**FRONT FACADE ON MILFORD STREET**

project title:
IMPROVEMENT TO THE FRONT FACADE, INTERNAL ALTERATIONS AND FORMALISING THE USE OF THE FLAT ROOF AS A OUTDOOR BREAKOUT SPACE.

plan title:
PLANS OF PROPOSAL
Window Schedule- Facade

plan N° / revision:
1501 /R5

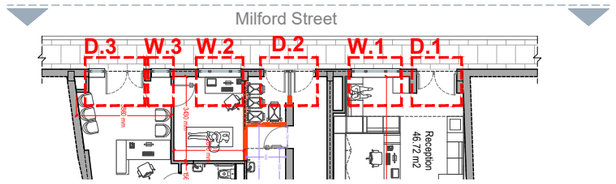
Amendments to facade following comments from Conservation Officer.

1. Bullnosed moulding removed
2. Painted plinth reduced to 400mm.
3. Removed additional signage over the central door.
4. Updated window and door width to reflect details shown on drawings 1502-1504
5. Rendering of ground floor of number 26 over brick removed.
